Annual Monitoring Report

Monitoring Year 6 of 7

Poplin Ridge Stream Restoration Project

RE: Poplin Ridge Stream Restoration Site: MY6 Monitoring Report (NCDMS ID 95359)

MY6 2020 Poplin Ridge UT2-A Flow Gauge

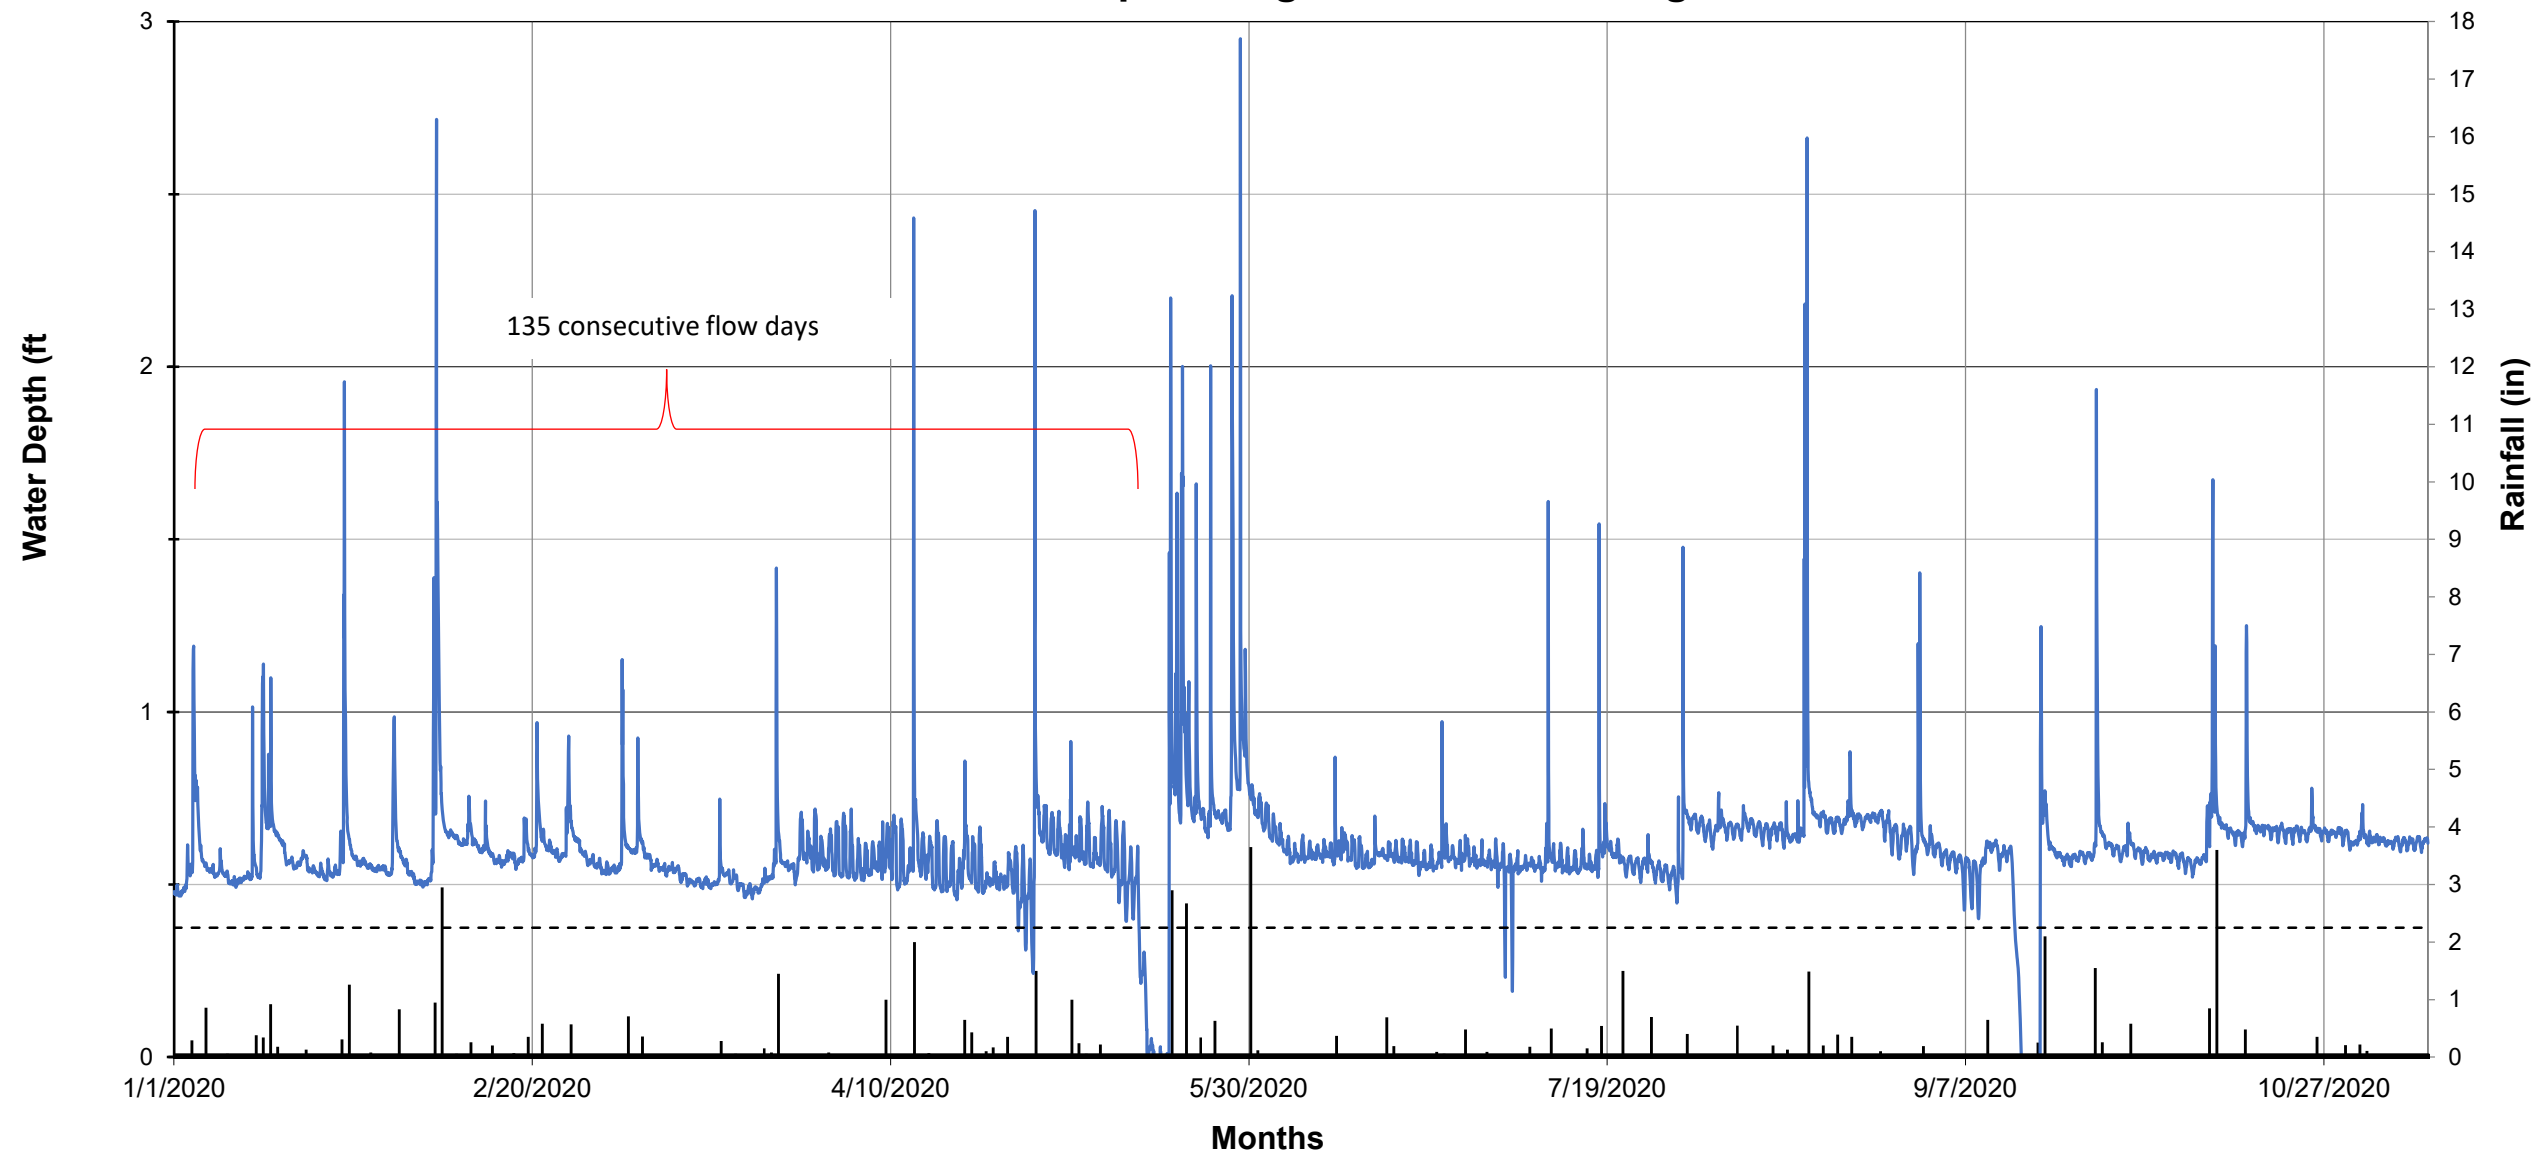
Appendix E – Flow Gauge Graph: DMS recommends showing the start and end points of the 135 days of consecutive flow reported.

Note that the data in the flow gauge figure is not plotted correctly in excel. Use the scatter plot (x,y) chart type, then add a line, rather than selecting the line chart type.
The line chart type has been changed to the scatter plot chart type.

[Done.](#)
